Ikes at Cambria
8001 28th Avenue South
PL201900209

CAMBRIA RESTAURANT

PRICING SET, 08-27-19

1 SITE PLAN
A1.1 SCALE: 1" = 30'-0"

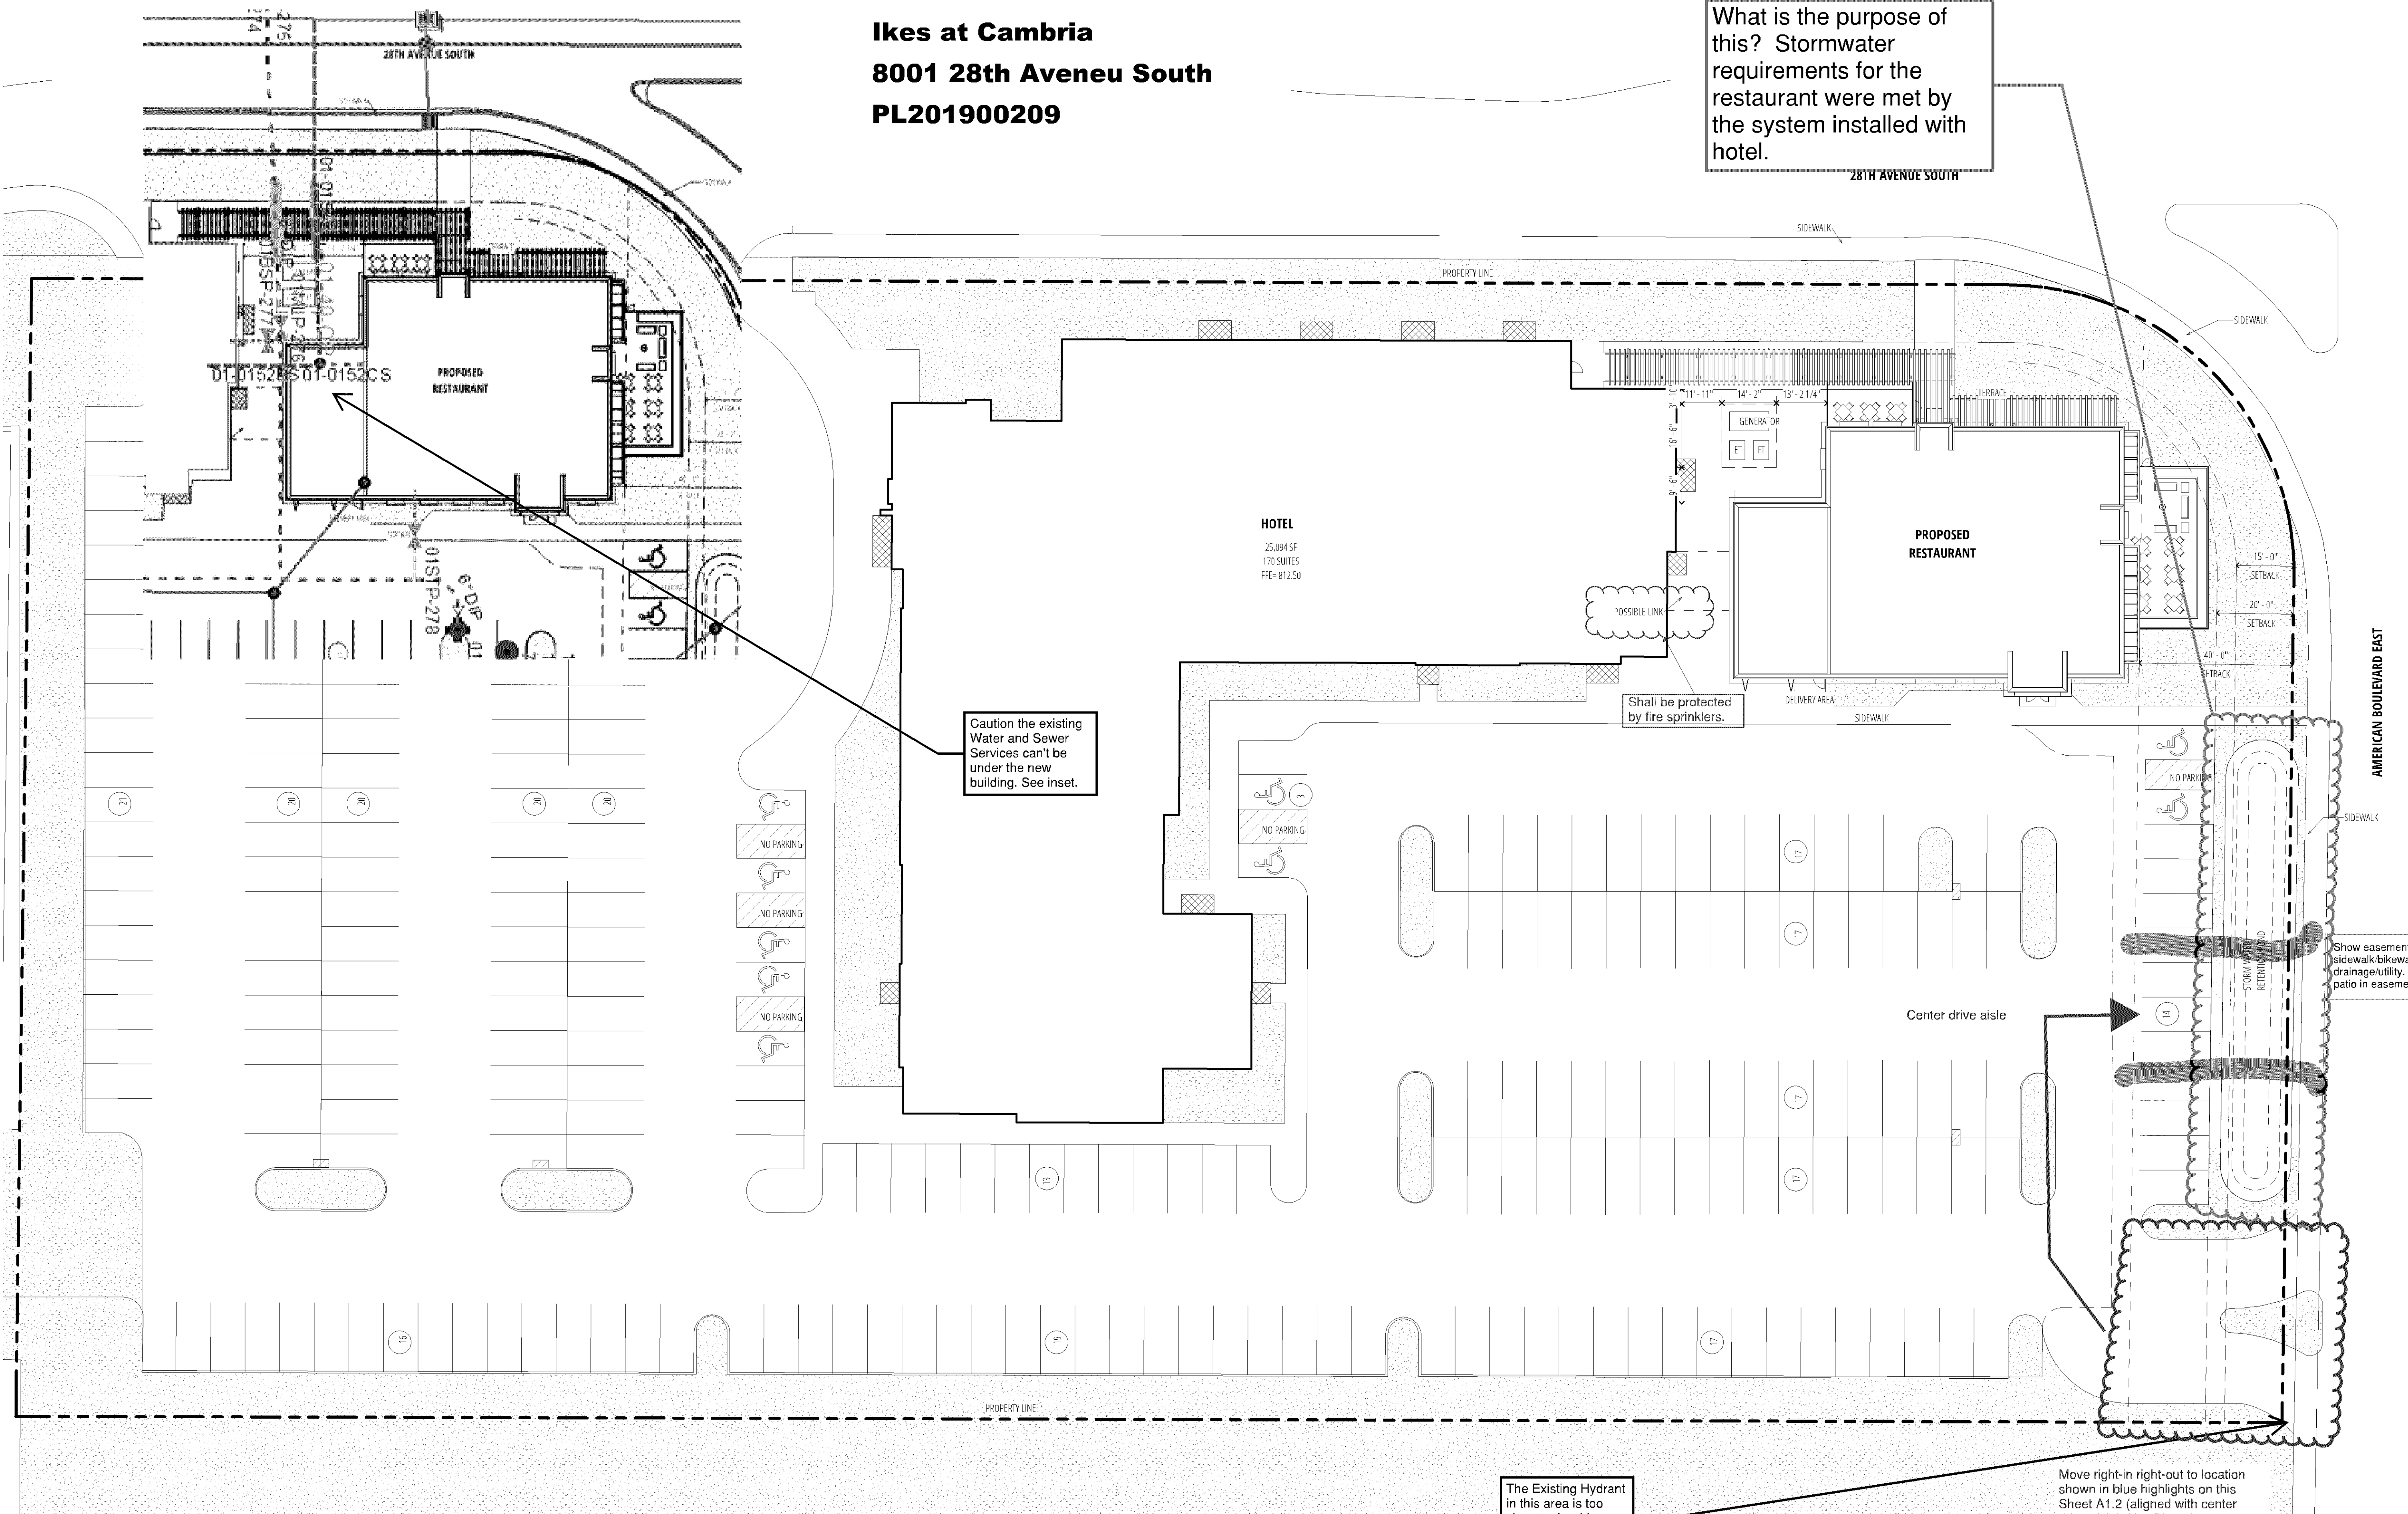
The Cambria Suites preliminary development plan included fully enclosed corridor between the hotel and restaurant. Consider retaining the shared corridor for the proposed restaurant.

Hydrant coverage shall be provided within 50' of the FDC and within 150' of all portions of the structure.

Fire alarm and annunciator panels and Knox box locations to be determined by the Fire Prevention Division.

Emergency responder radio coverage meeting the requirements of appendix L in the 2015 MSFC shall be provided throughout the property and within the structures.

Insure kitchen hood suppression system is an approved UL300 listed system connected to the building's fire sprinkler system.

Fire Department Connection Shall Be front (main entrance) side of building.

insure the proposed landscaping doesn't interfere with access to the building.

Show easements: sidewalk/bikeway and drainage/utility. No pond or patio in easement area.

Correct demolished parking island line work.

13 stalls are depicted along American Blvd. The plan label is 14.

Radius on adjacent parcel.

Proposed location of right-in right-out driveway aligns ingress and egress traffic nearly head on, depicts radius extending onto adjacent parcel, and also does not position egress traffic well for accessing the eastbound left turn bay to facilitate an EB to WB u-turn movement (pink highlight).

Move right-in right-out to location shown in blue highlights which will facilitate access into the start of the EB left turn bay. Use Bloomington standard commercial driveway detail and no splitter island.

1 ENLARGED SITE PLAN
A1.2 SCALE: 1" = 20'-0"

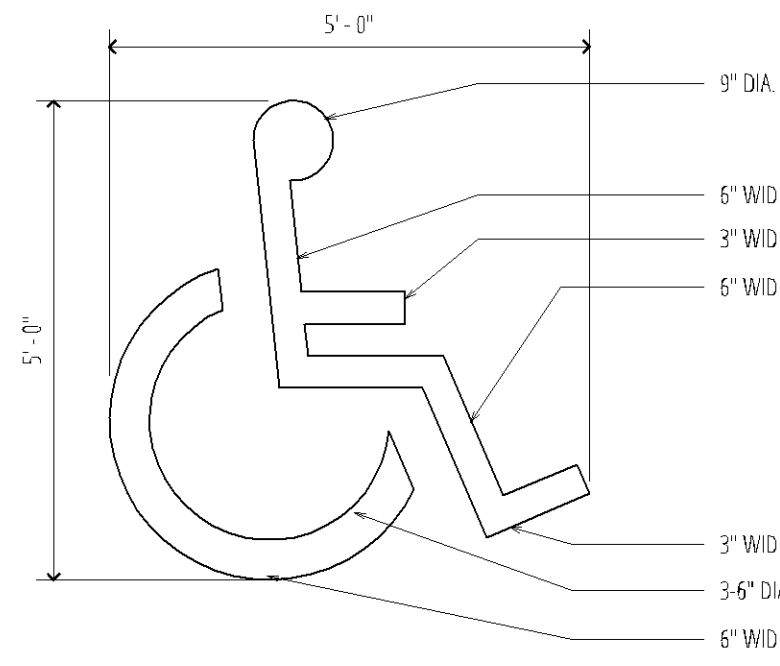
What is the purpose of this? Stormwater requirements for the restaurant were met by the system installed with hotel.

2 RETAINING WALL DETAIL
A1.3 SCALE: 1/2" = 1'-0"

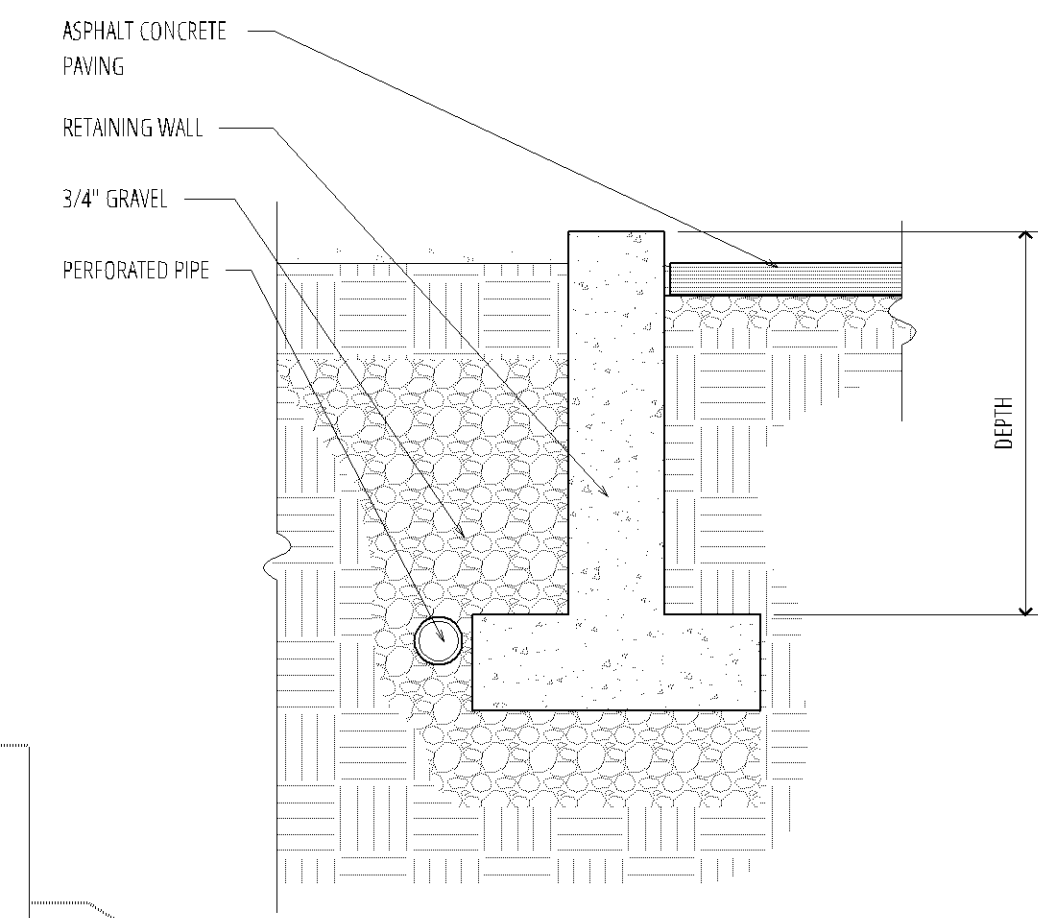
This detail does not match grading plan.

4 CONCRETE CURB DETAIL
A1.3 SCALE: 1 1/2" = 1'-0"

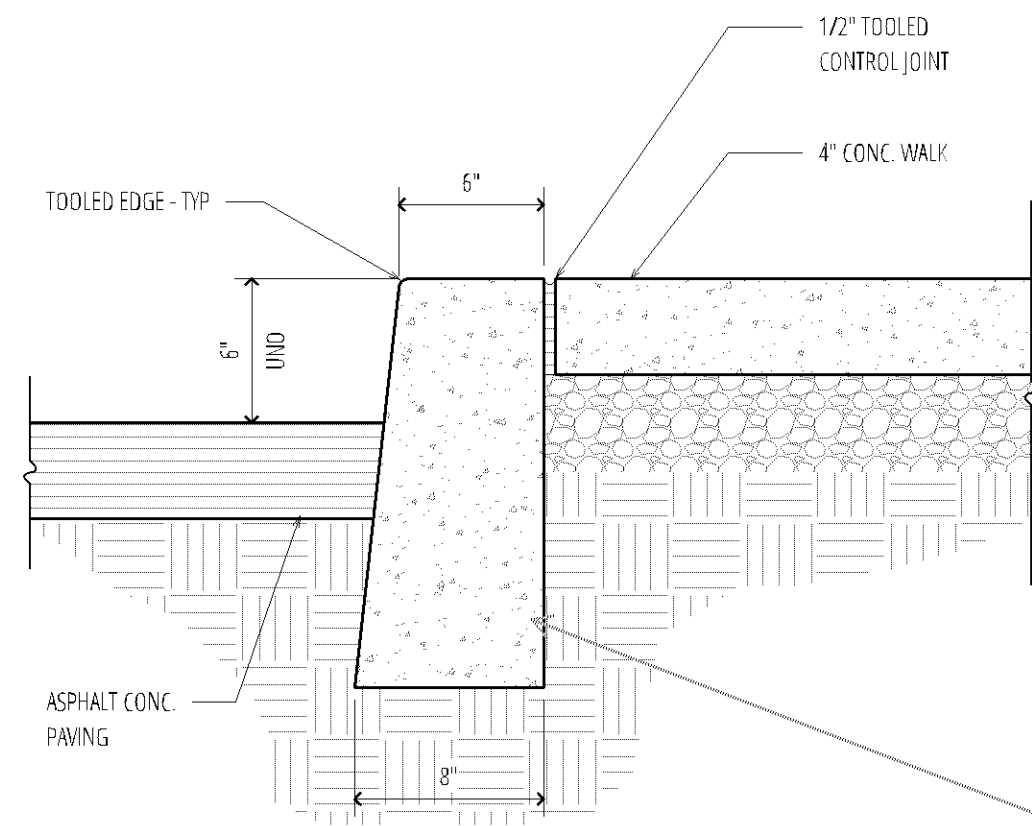
Depth is not show for curb detail
